# CITY PLAN COMMISSION STAFF REPORT

The Dotte at Metro North

CD-CPC-20214-00071  
Development Plan - Residential

## Plan Conditions, Corrections, & Suggestions Report

EXISTING CONDITIONS / TREE  
PRESERVATION PLAN  
Development Plan for:  
The Dotte at Metro North  
Kansas City, Clay County, Missouri

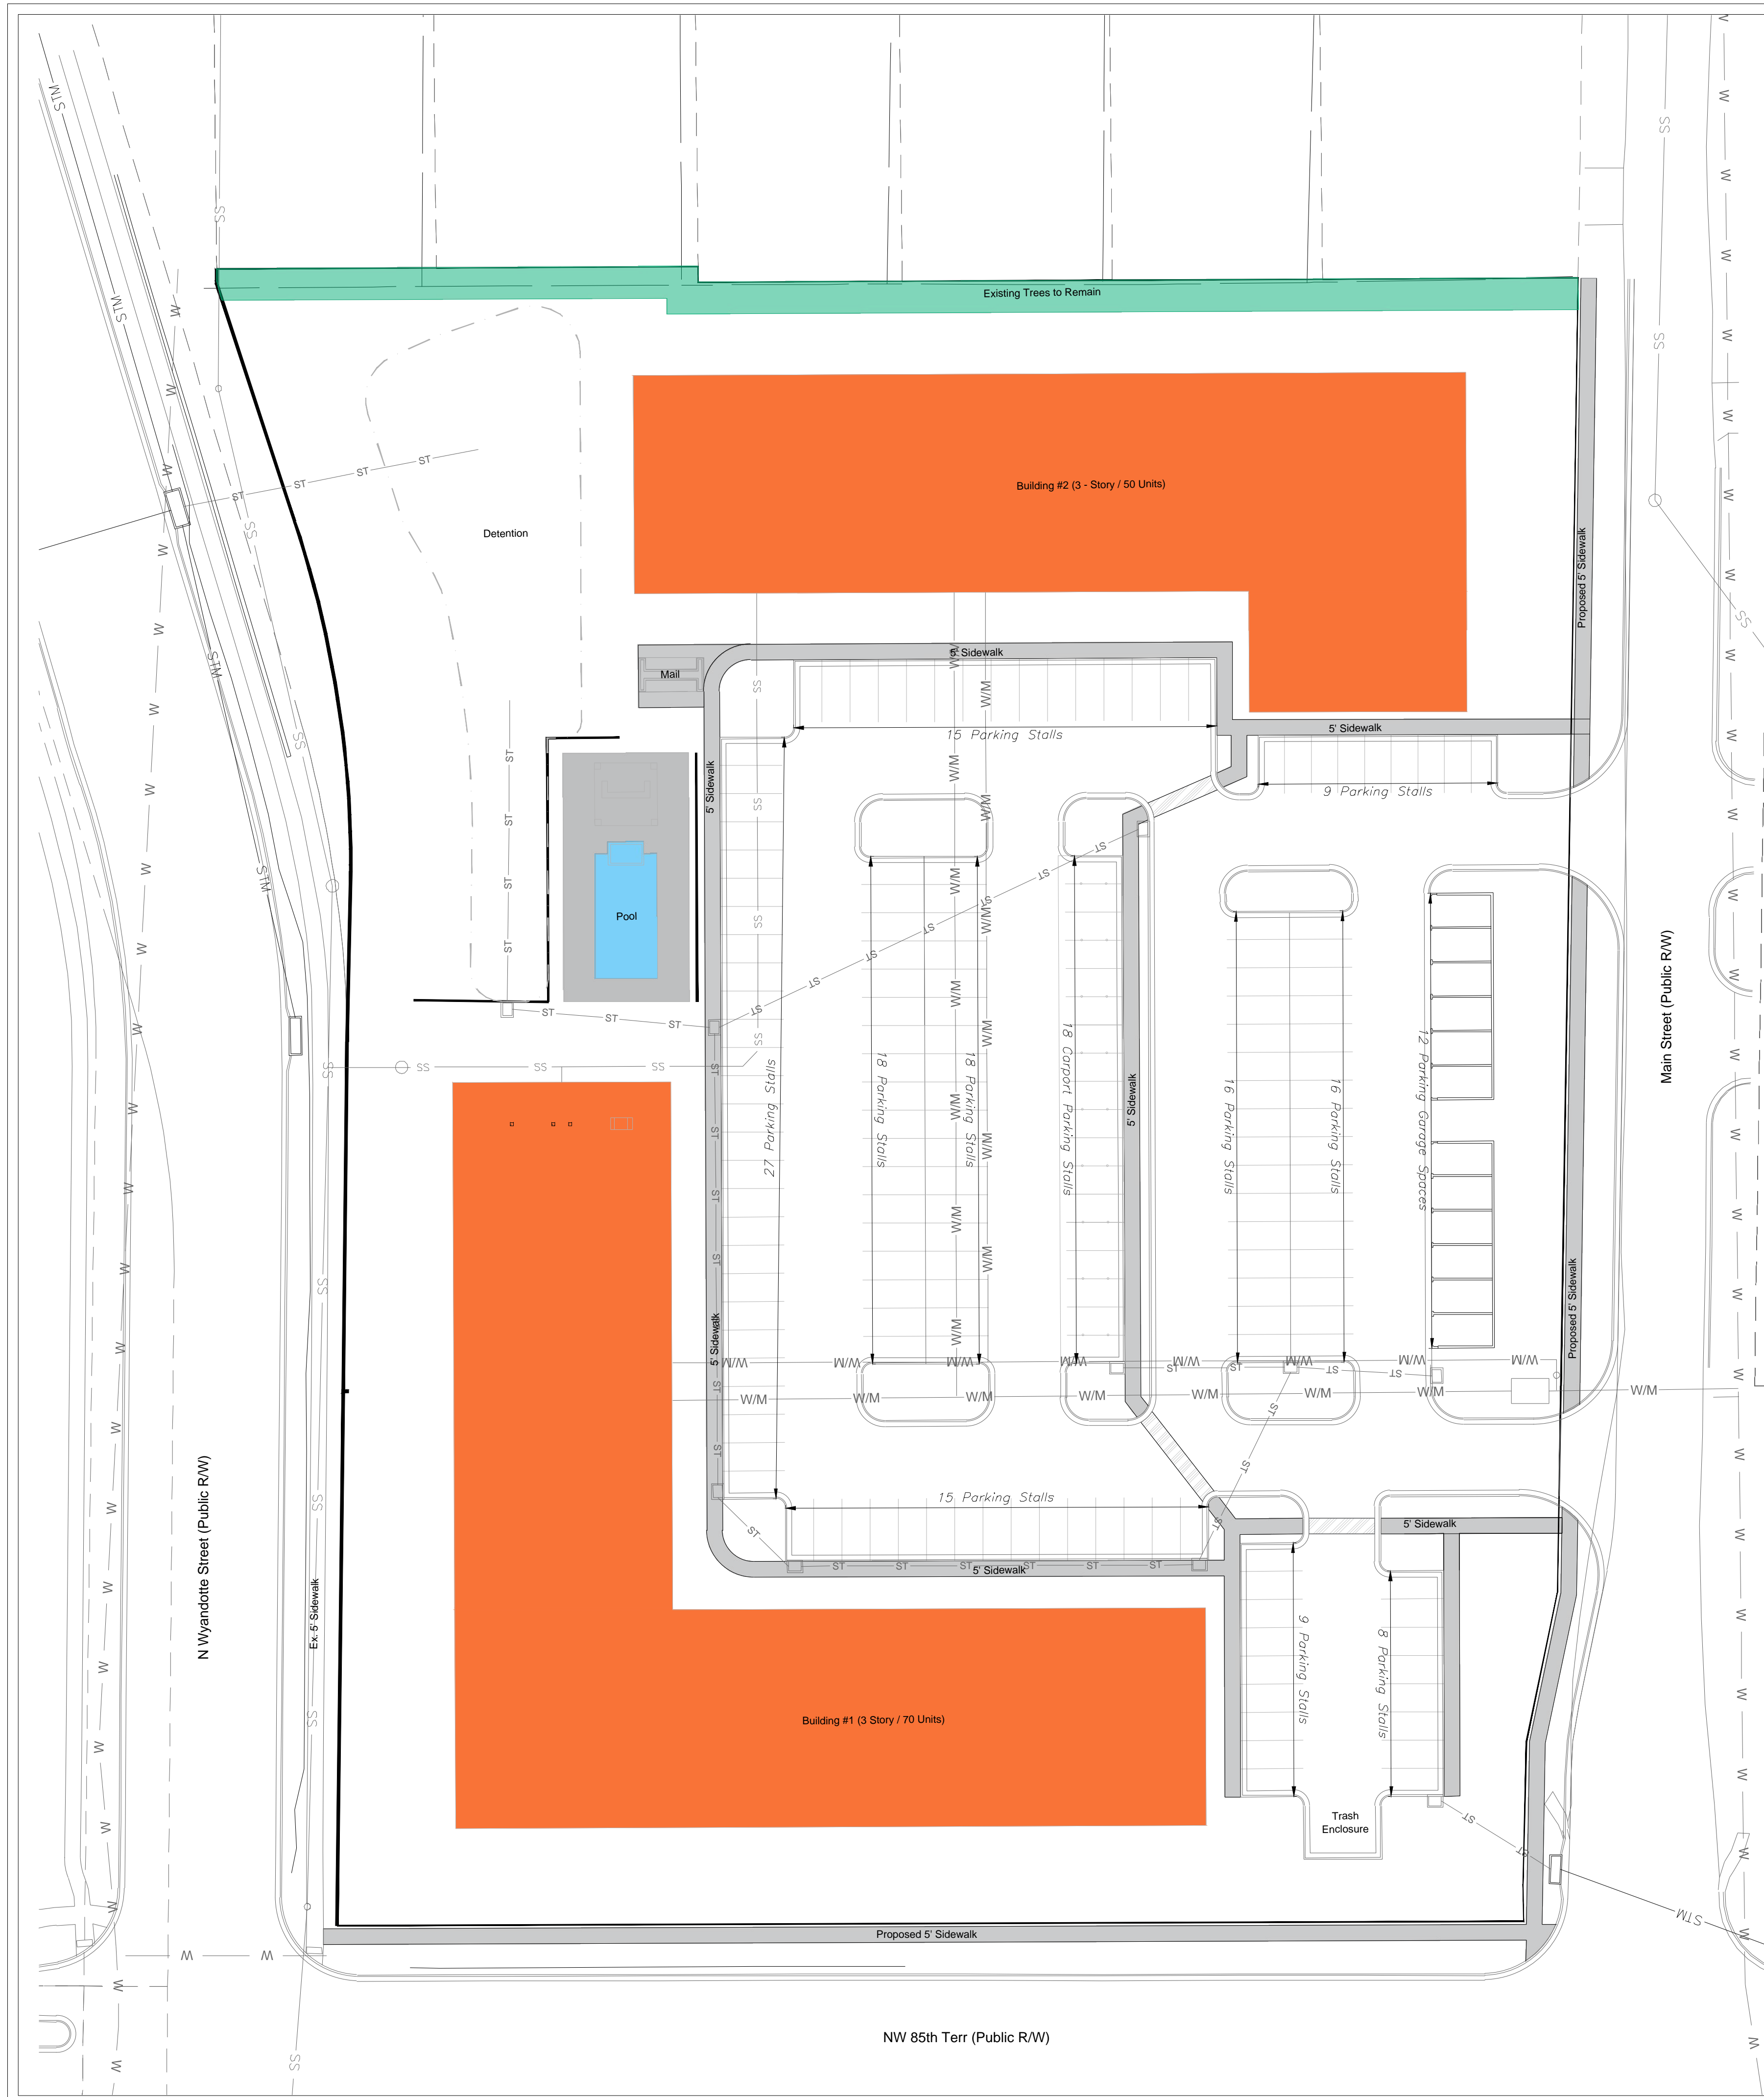
5. Add a note to the drawing of existing trees to be removed. UPDATE 7/1/24: The label on C.002 should be changed from "Ex. Tree Mass" to "Ex. Tree Mass to be Removed" (6/28/2024)
6. UPDATE 7/1/24: 12 trees are required for mitigation based on 2" caliper trees, not 8. Revise tree mitigation plan (C.002) and landscape plan (L.100). Additionally, landscape plan indicates 3" trees and all should be 2". (6/28/2024)

Landscape Plan  
 Development Plan for:  
 The Dotte at Metro North  
 Kansas City, Clay County, Missouri

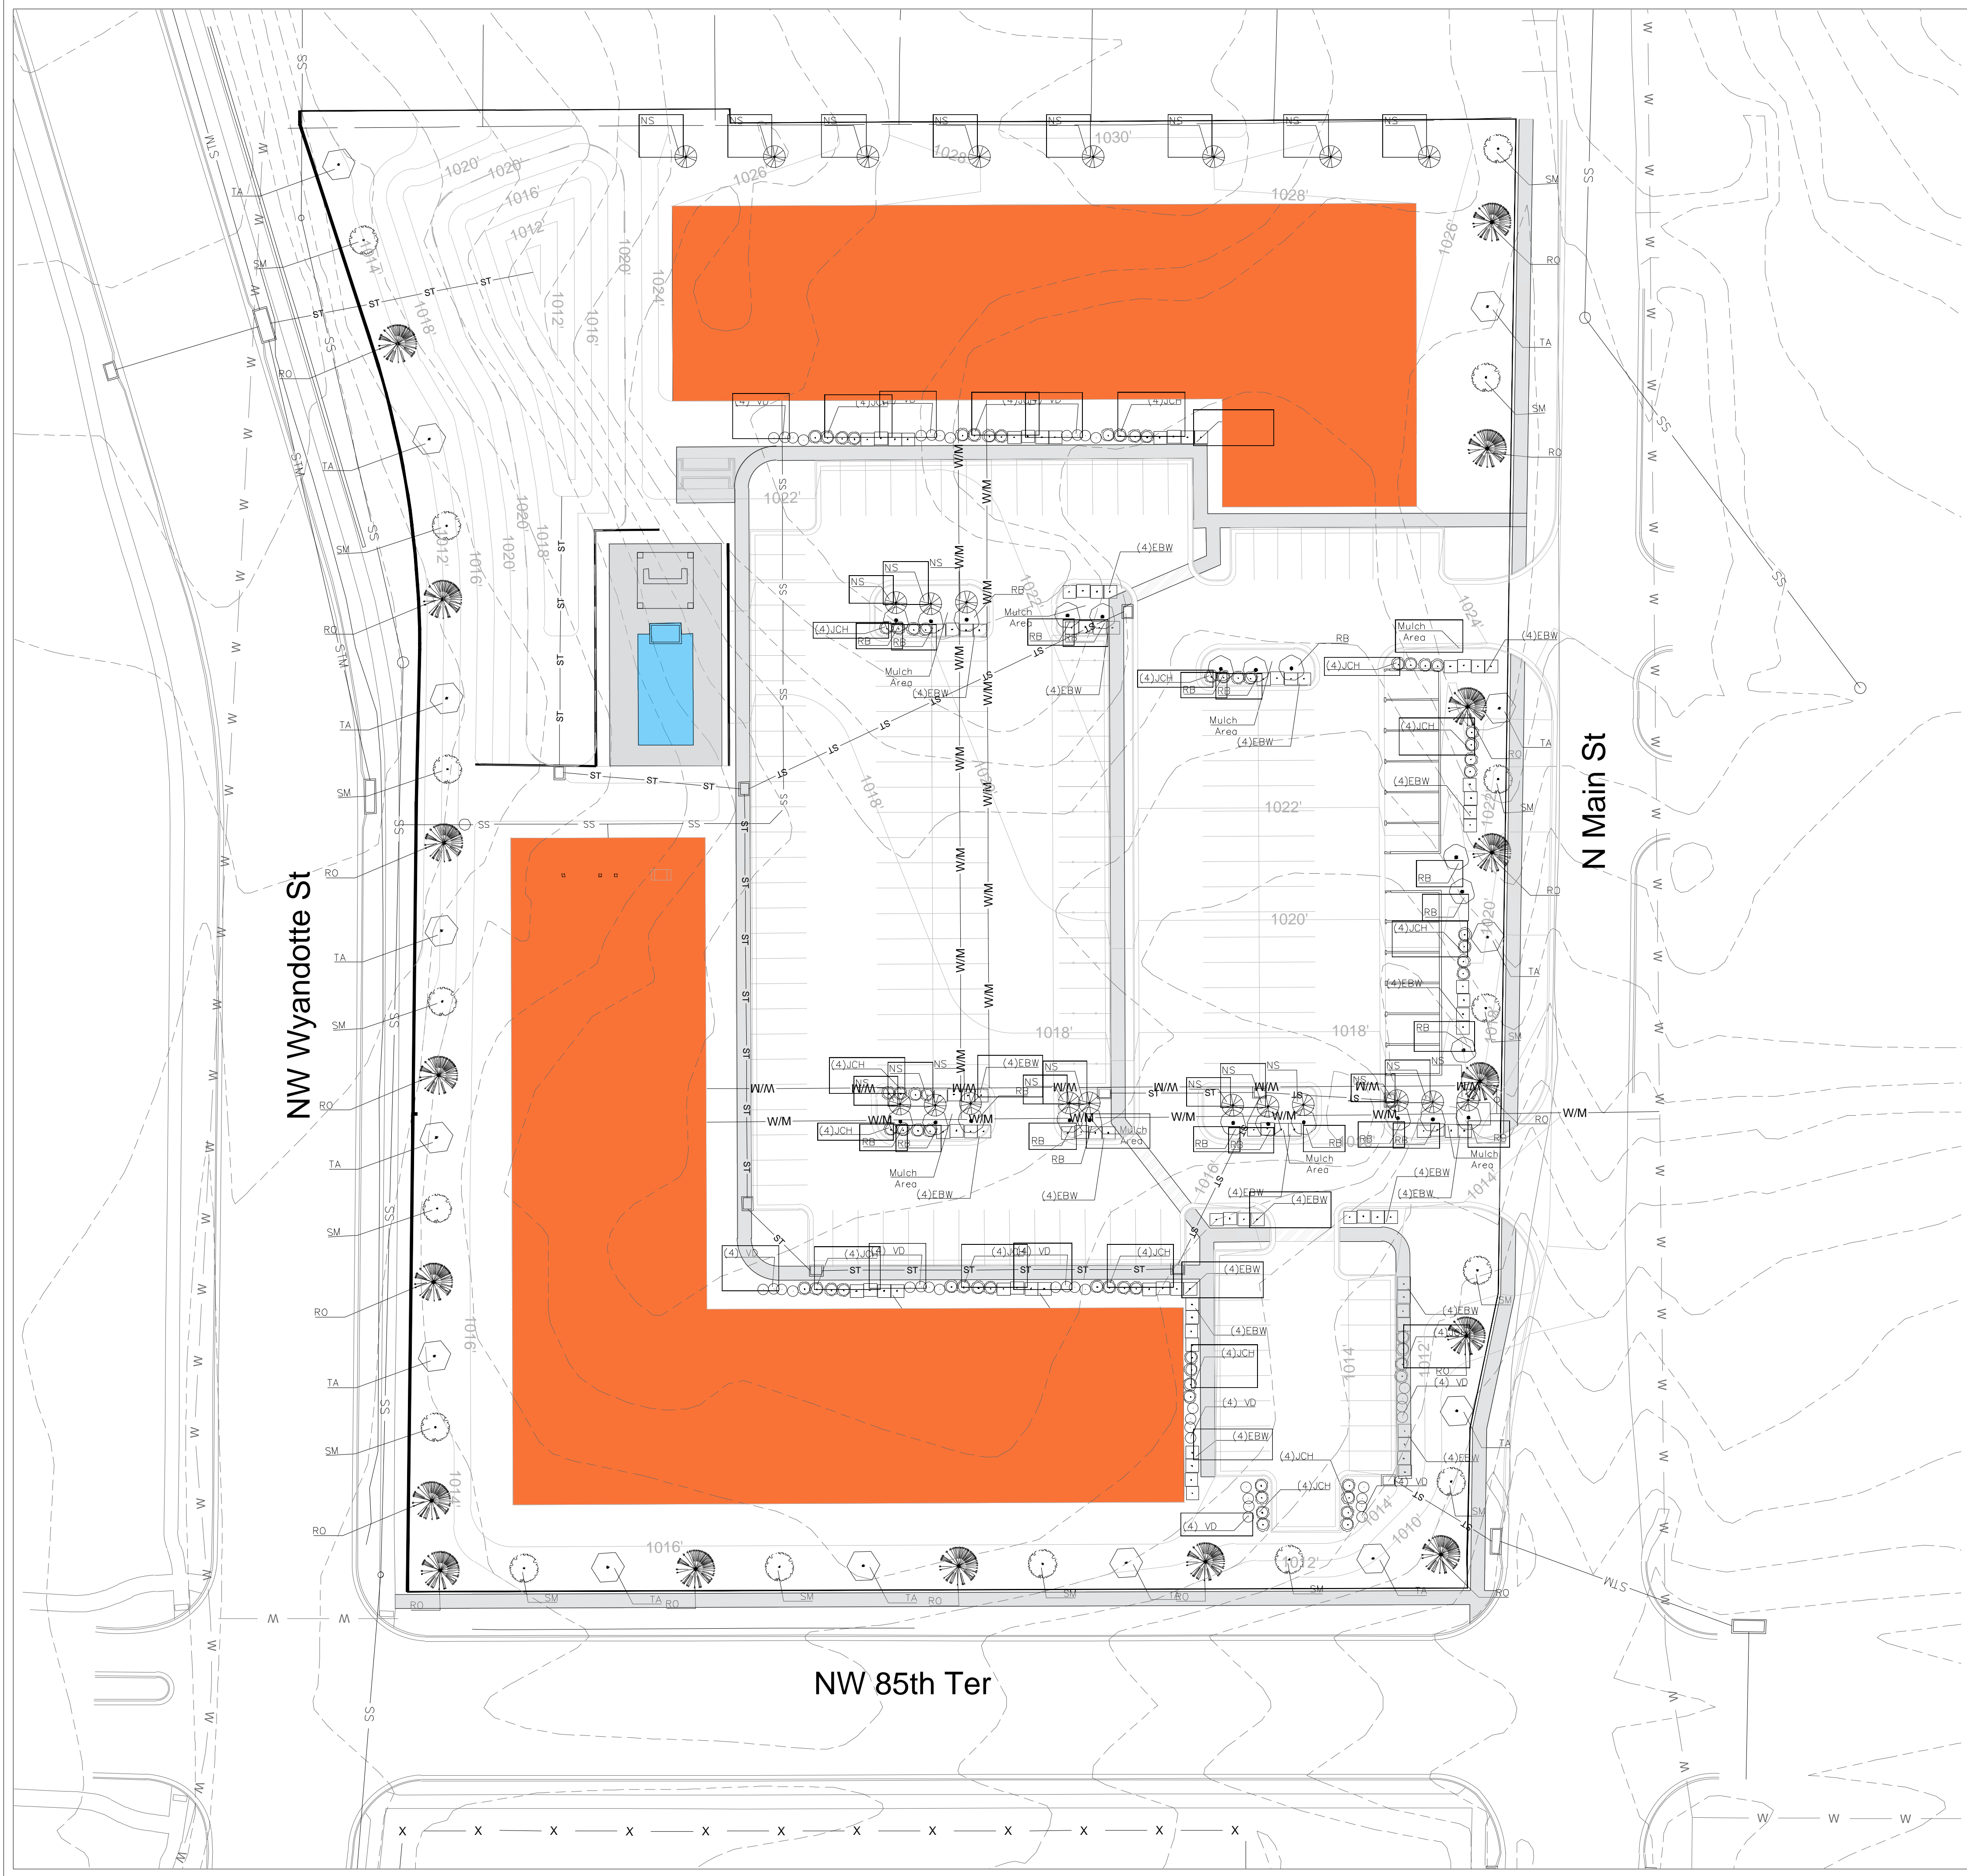
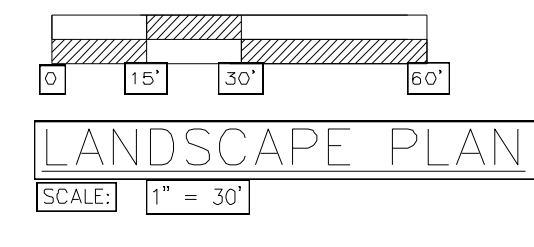
1. Will the stormwater detention area be planted with native variety of grasses to enhance? Identify native seed mix for this area on the landscape plan. UPDATE 7/5/24: provide this label on the landscape plan drawing and seed mix specifications. (6/28/2024)
2. 40 long term bicycle spaces are required (1 space per 3 dwelling units). Individual garages can be counted towards this requirement. UPDATE 7/5/24: building and site data table was removed from the plans. Please revise the table and add it back to the plan set. (6/28/2024)
3. 18 short term bicycle spaces are required (10% of actual number of vehicle parking spaces provided). UPDATE 7/5/24: building and site data table was removed from the plans. Please revise the table and add it back to the plan set. (6/28/2024)
4. 88-425-12 requires the landscape plan to be sealed by a MO licensed landscape architect. (6/28/2024)
